**AIRWORTHINESS ADVICE  
NOTICE**

**TYPE AFFECTED:** SZD-9bis Bocian 1D and 1E.  
**SUBJECT:** Miscellaneous airworthiness information.  
**BACKGROUND:** This AN records airworthiness information which is useful to know.

**FIGURE 1 - UNDERCARRIAGE BOLT**

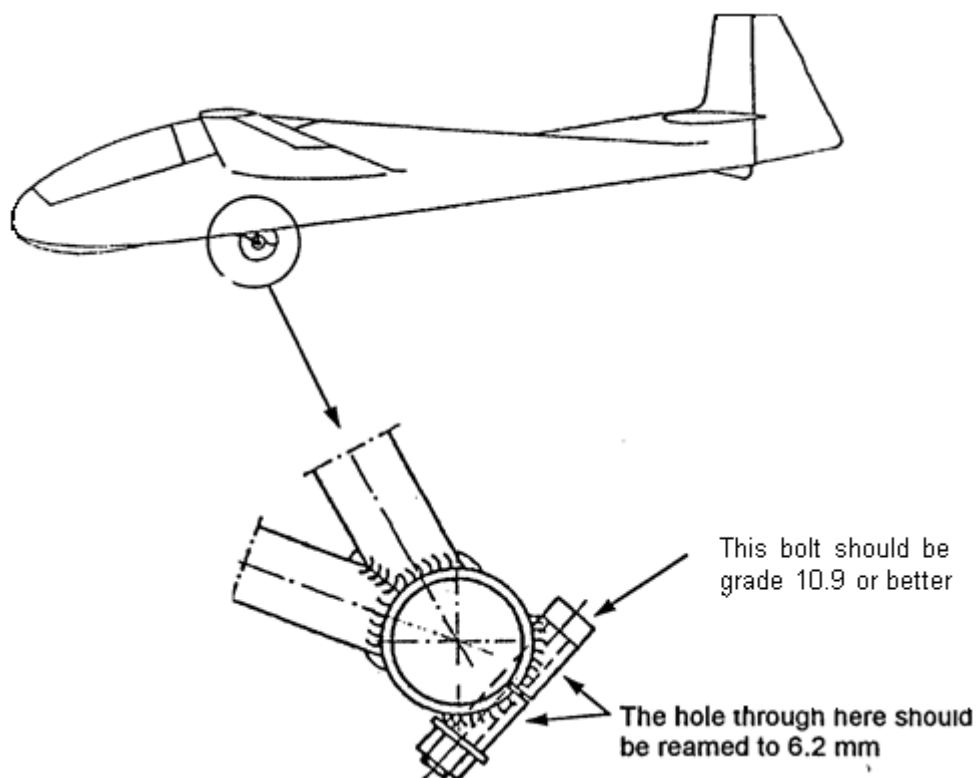
2. Bulletin BK-005/73 Bocian required the replacement of the axle clamping bolt to prevent damage to the axle clamps on all 1E Bocians. These bolts should be checked at each annual inspection and if replacement is necessary then the replacement bolts should be grade 10.9 M6 x 40 mm bolts and the hole which they fit into should be reamed to 6.2 mm Ø. See Figure 1

**FIGURE 2. - PULLEY**

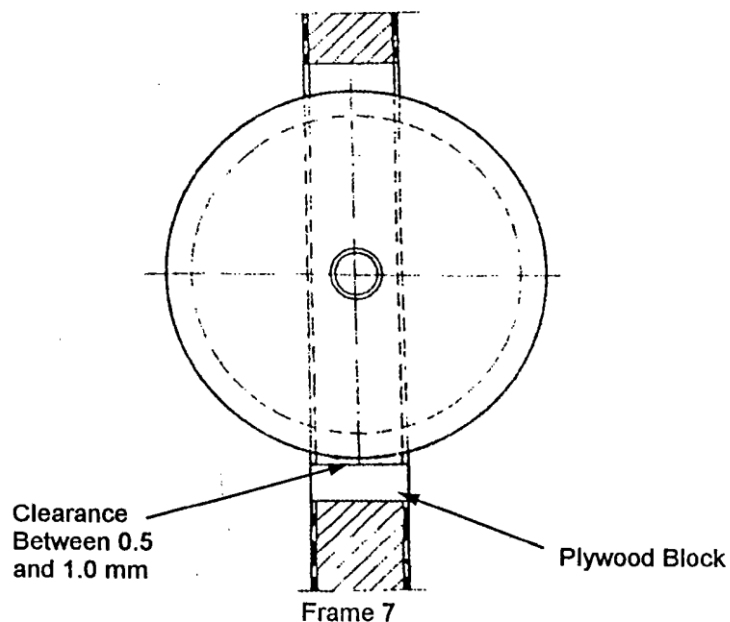
4. Bulletin NR-008/76 Bocian describes the possibility of the rudder control cable dismounting from the pulley attached to number 7 bulkhead on IE Bocians up to serial number P-753. A plywood block should be glued onto the bulkhead to reduce the clearance between the pulley and the bulkhead to between 0.5 and 1.0 mm as shown in Figure 2

**FIGURE 3 - REPLACEMENT ECCENTRIC**

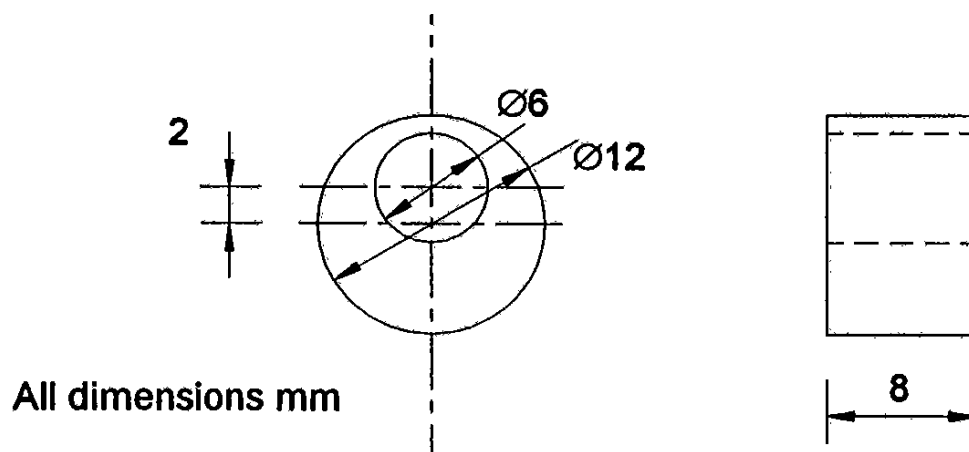
5. Bulletin BK-14/78 describes the adjustment of the airbrake stops in Bocian IE however the English is so poor it is difficult to know what was required. It is however possible to determine that one of the requirements was to fit a rubber block to the front seat pan to act as an out stop. Also if the eccentric stop in the wing allows the dive brake components to contact each other then it should be replaced with one as shown in Figure 3.
